BALTIMORE COUNTY, MARYLAND
DEPARTMENT OF PUBLIC WORKS AND TRANSPORTATION
DIVISION OF CONSTRUCTION CONTRACTS ADMINISTRATION
111 WEST CHESAPEAKE AVENUE
TOWSON, MARYLAND 21204

Contract Number 24084 SX0
Richlyn Manor Force Main
Perry Hall – District 11c5
Workday Number PROJ-1000060

ADDENDUM NO. 1

DATE: 5/14/2026

PLAN: STA. 21+50 TO STA. 25+50
SCALE: 1"=20'-0"

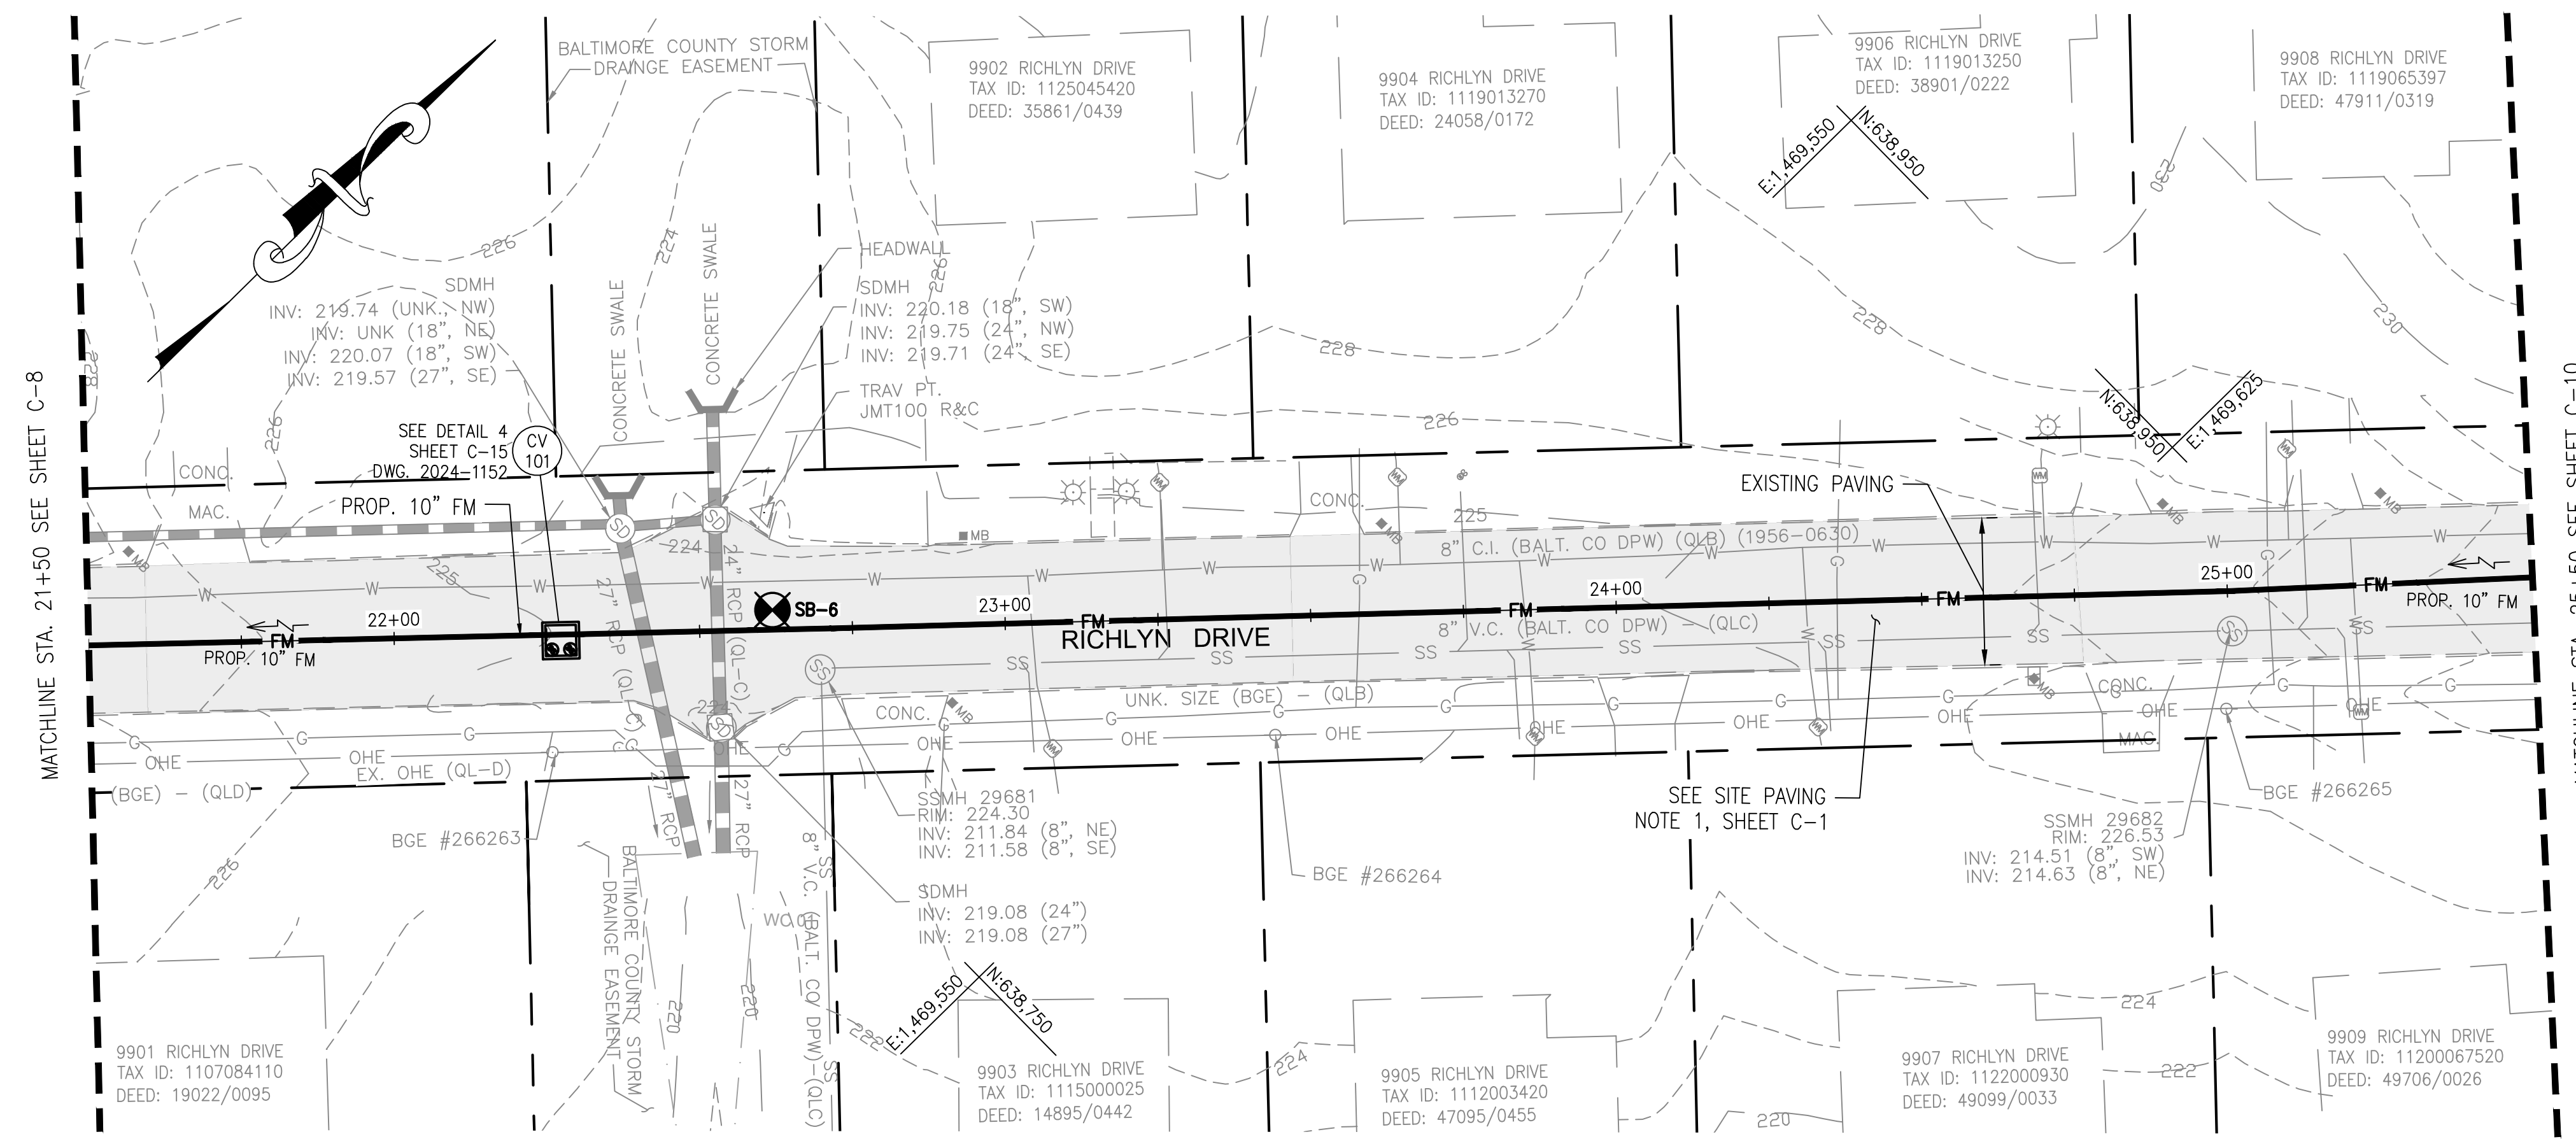
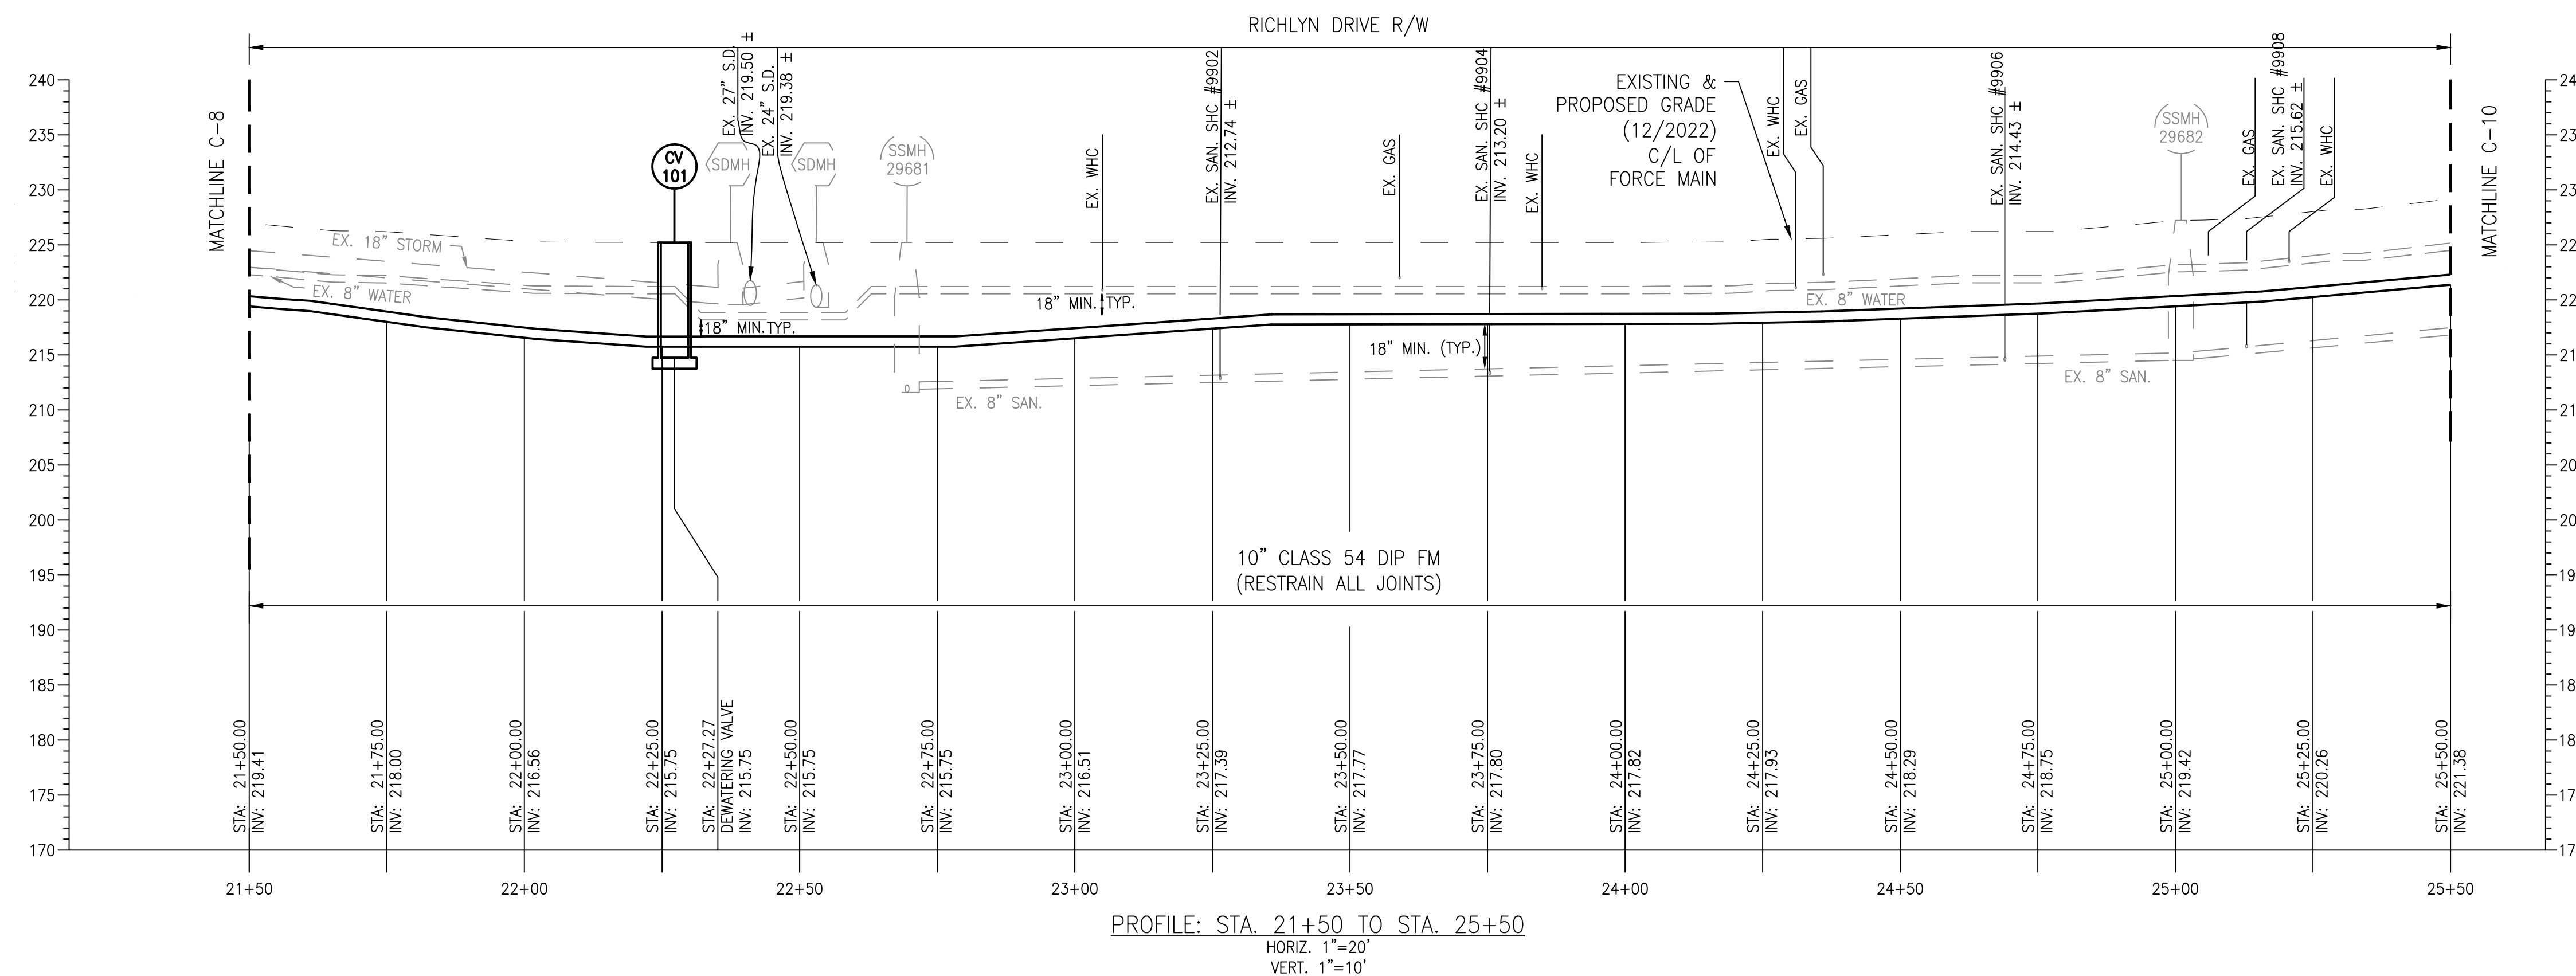
6. Drawing 2024-1146, C-9: Replace Sheet C-9 in its entirety with the attached revised Sheet C-9 which moves the dewatering vault from Station 22+61.87 to Station 22+27.27.

PLAN: STA. 33+50 TO STA. 38+50
SCALE: 1"=20'-0"

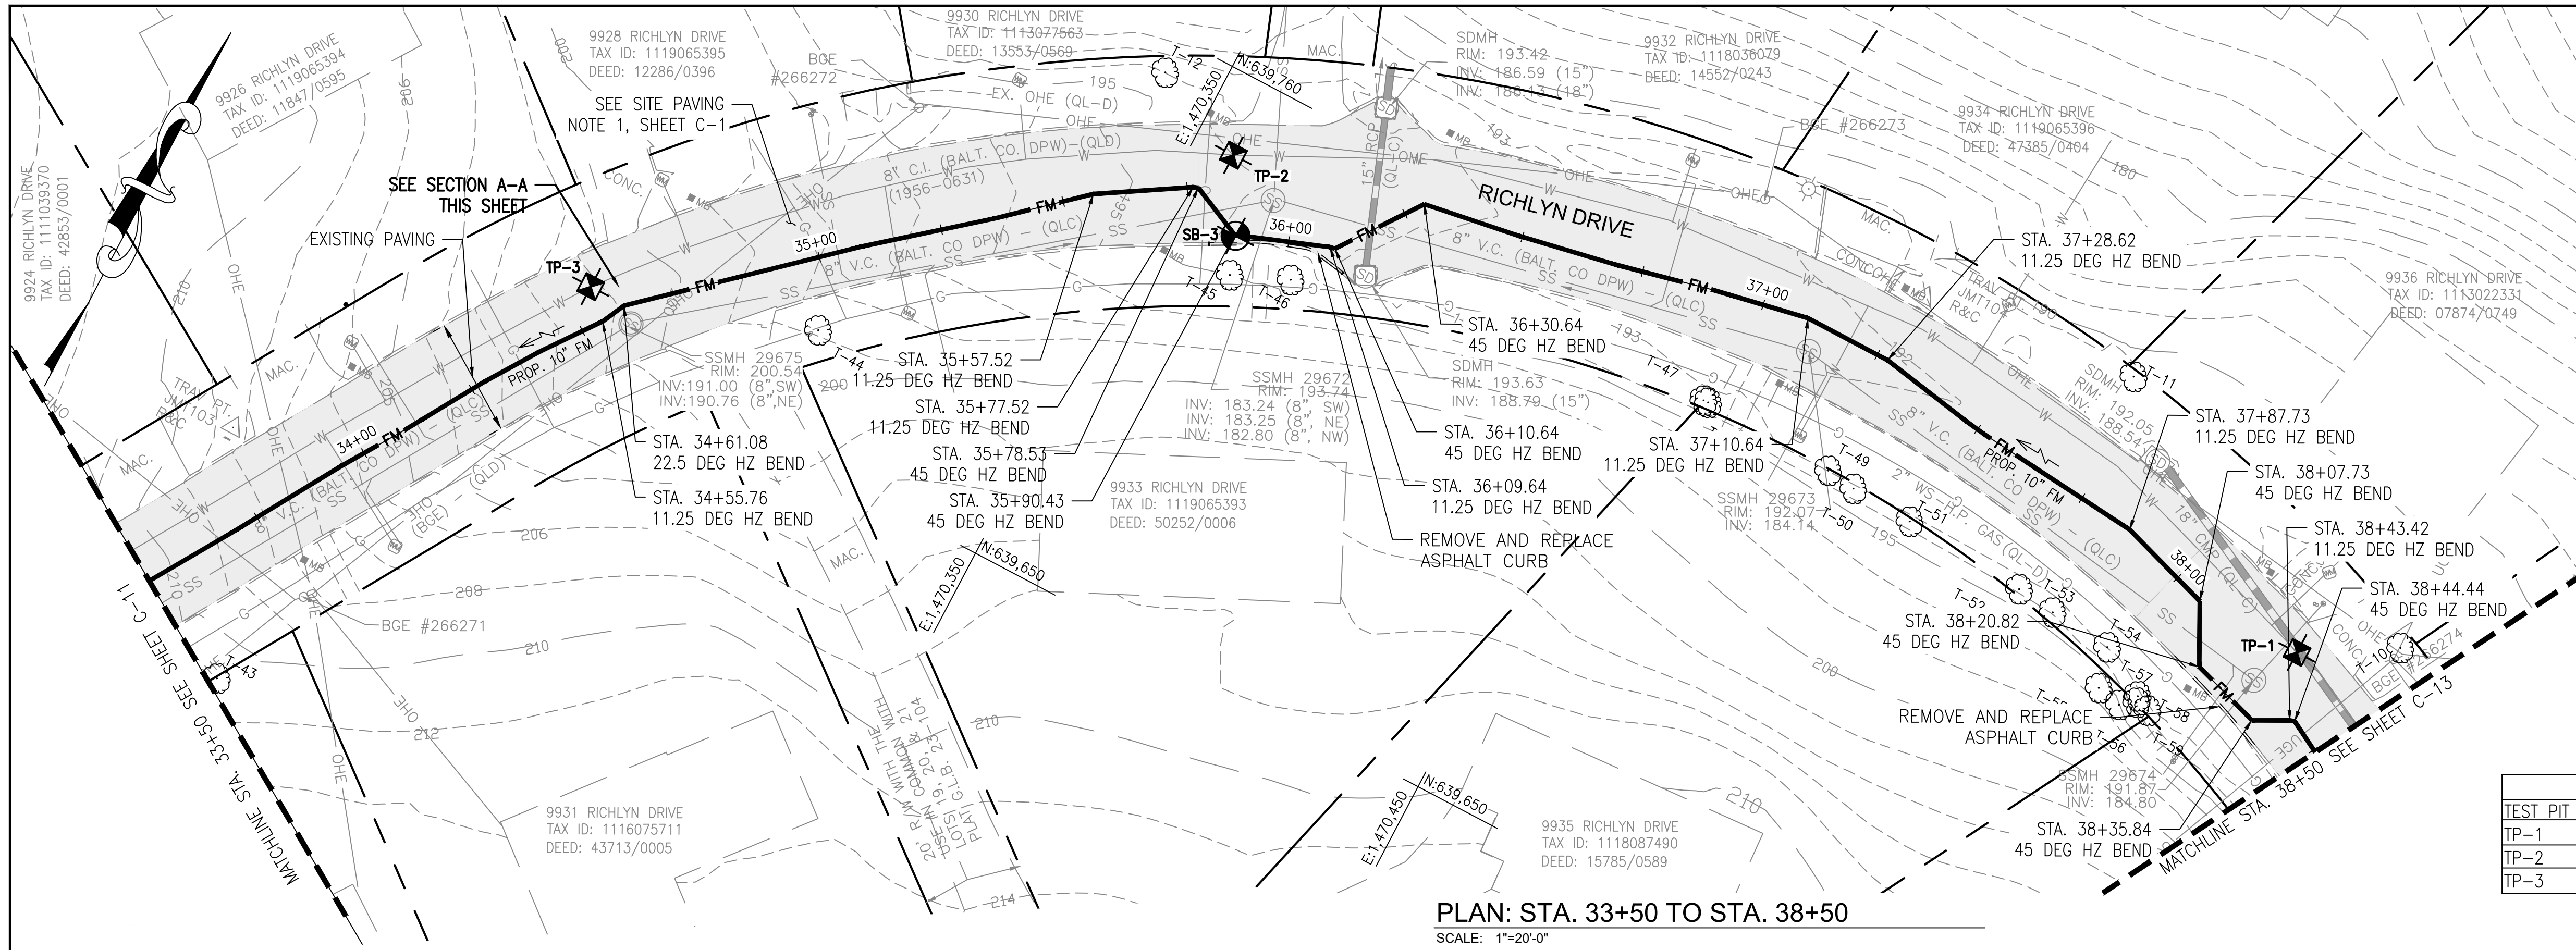
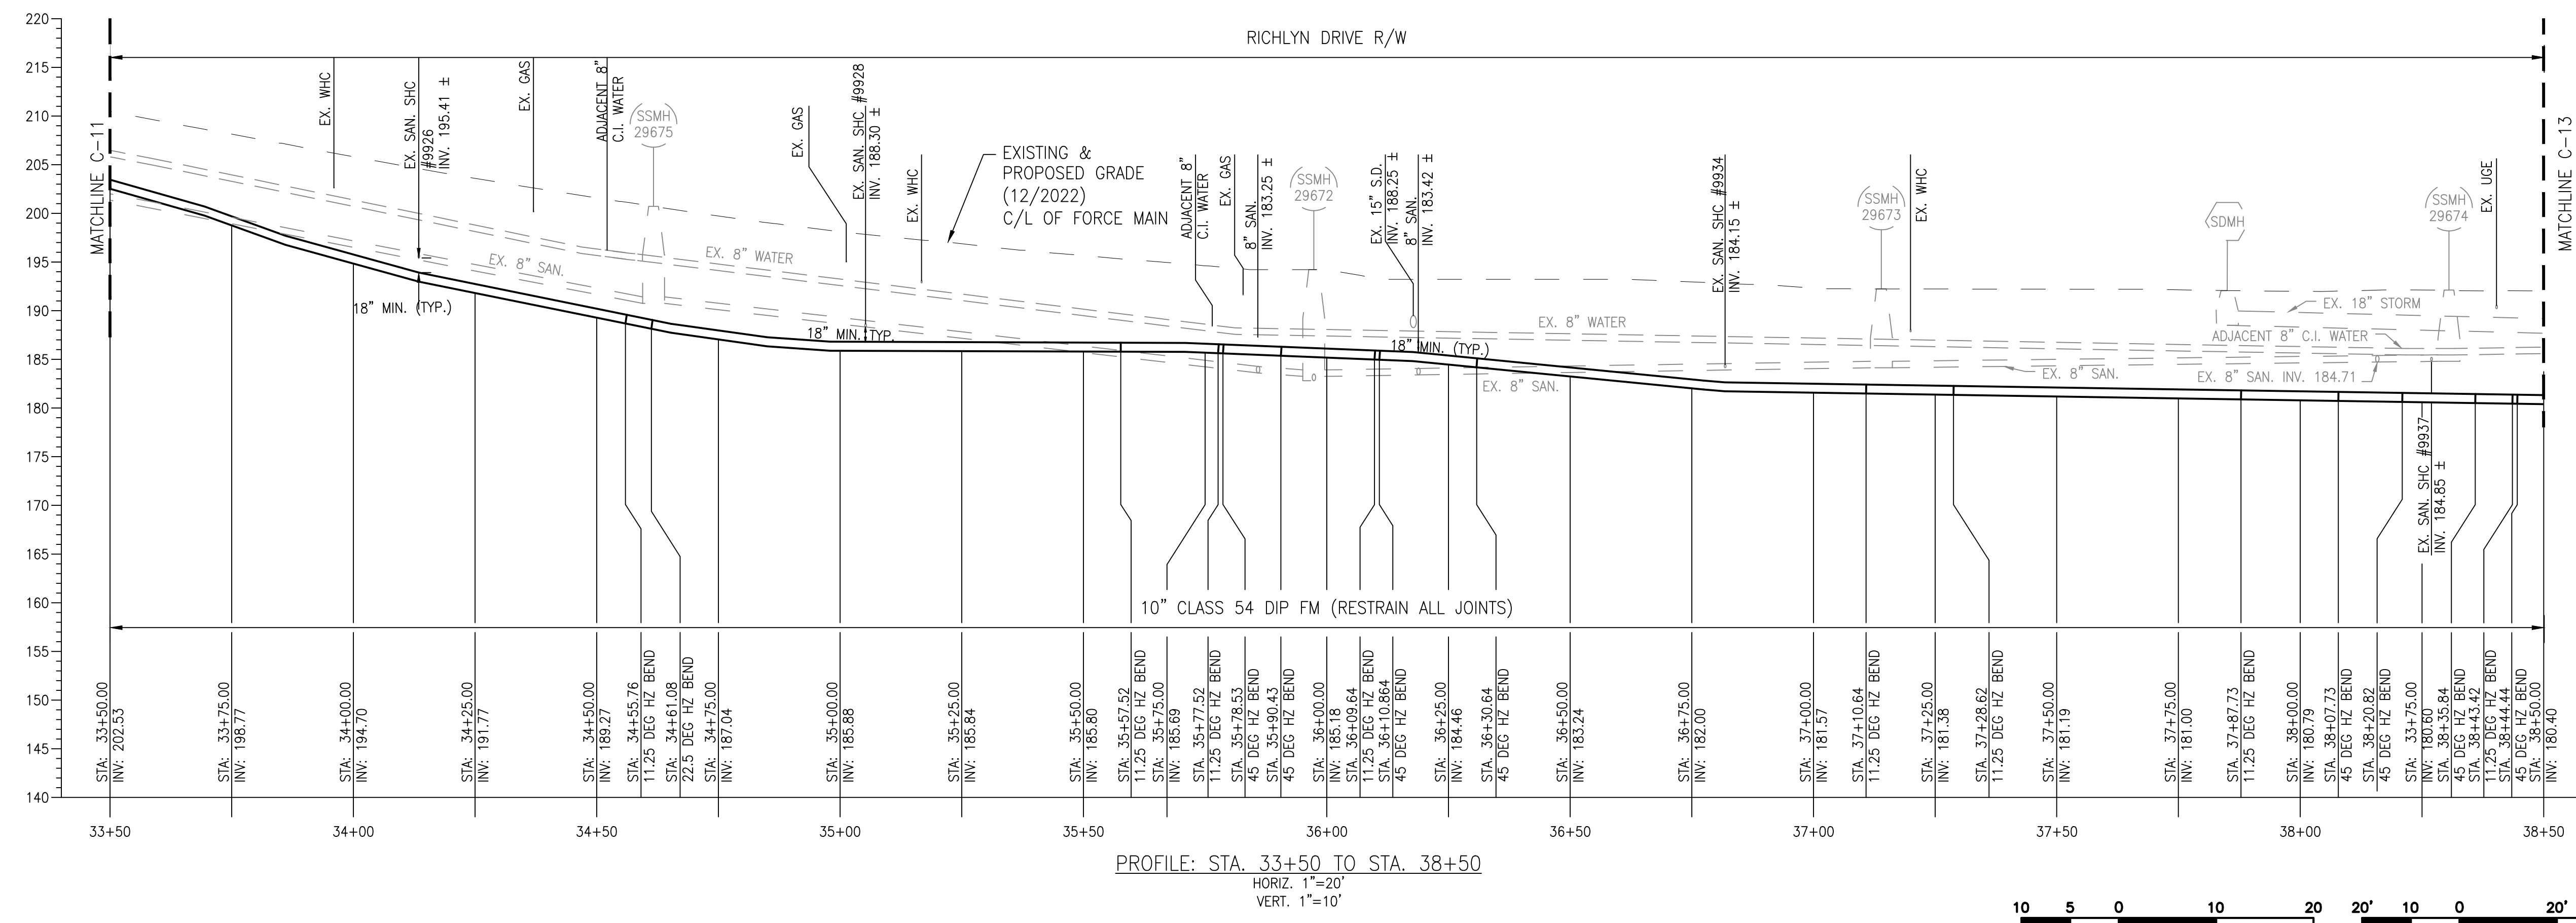
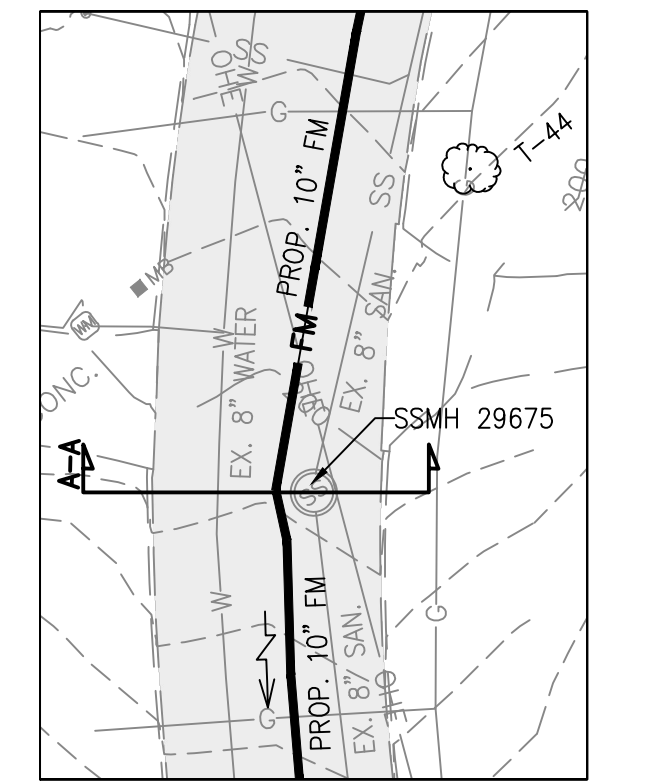
7. Drawing 2024-1149, C-12: Replace Sheet C-12 in its entirety with the attached revised Sheet C-12, which has been updated to include BGE underground electric utility near STA 38+44.44.
